Access Compliance Report Public Rights-of-Way (Curb Ramps)

Main Street: **BROWNING_AVE** Cross Street: **BURNT_MILL_RD** Location: **SE**

ADA ID: **RPAT211012110443** Ramp Type: **Type 1 - Perpendicular Diagonal Initial Pass/Fail: Pass** Overall Compliance: **No** Severity Score: **10**

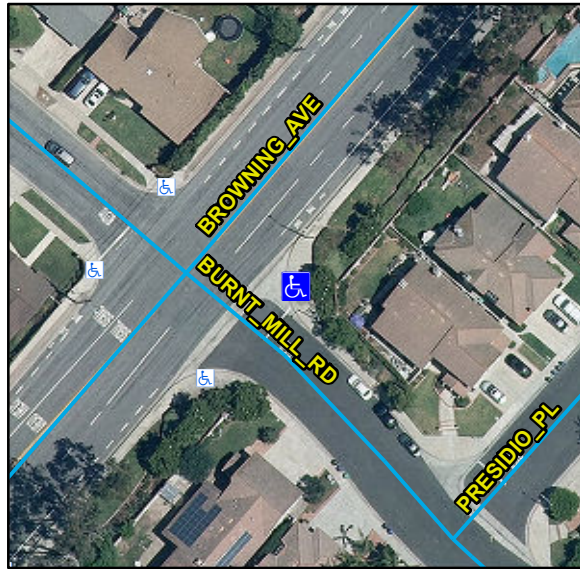
Compliance	Description	Data	Compliance	Description	Data
N/A	Ramp Length (in)	105	N/A	Flare Type LT	
Yes	Ramp Width (in)	50			Sloped
Yes	Ramp Run Slope (%)	4.9	Yes	Flare Slope LT (%)	9
Yes	Ramp Cross Slope (%)	1.2	N/A	Flare Traversable LT	Yes
N/A	Landing Present	Yes	N/A	Flare Type RT	
N/A	Landing Length (in)	65			Sloped
Yes	Landing Width (in)	124	Yes	Flare Slope RT (%)	7.3
Yes	Landing Run Slope (%)	0.3	N/A	Flare Traversable RT	Yes
Yes	Landing Cross Slope (%)	1.8	No	DWS Provided	No
N/A	Landing Movement Obstructed?	No	N/A	DWS Contrast	N/A
	Landing Movement Type	N/A	N/A	DWS Length (in)	N/A
N/A	Landing Shared	No	N/A	DWS Full Width	N/A
N/A	Clear Space	Yes	N/A	DWS Offset Left (in)	N/A
N/A	Clear Space To Crosswalk (in)	48	N/A	DWS Offset Right (in)	N/A
N/A	Marked Crosswalk 1	No	N/A	Marked Crosswalk 2	No
	Crossing 1 Direction	N		Crossing 2 Direction	W
	Marked Crosswalk 1 Width (in)	N/A		Marked Crosswalk 2 Width (in)	N/A

N/A	Ramp Inside Crosswalk 1	N/A	Yes	Ramp Inside Crosswalk 2	N/A
	Crossing 1 Slope (%)	2.1		Crossing 2 Slope (%)	0.2
	Crossing 1 Cross Slope (%)	0.1		Crossing 2 Cross Slope (%)	1.2
Yes	Gutter Ponding	No	Yes	Curb Slope	0.4
Yes	Gutter Lip Height (in)	0		Road Run Slope (%)	1.6
Yes	Gutter Run Slope (%)	4		Road Cross Slope (%)	1.1
Yes	Gutter Cross Slope (%)	0.8			
Yes	Overall Surface Condition: Acceptable		No	Perp Joint Present	No
	Cross Gutter Present?	Yes		Spandrel Present?	Yes
	Replace Cross Gutter?	No		Replace Spandrel?	No

Remove & Replace Curb Ramp With Two New Directional Ramps or Equivalent.
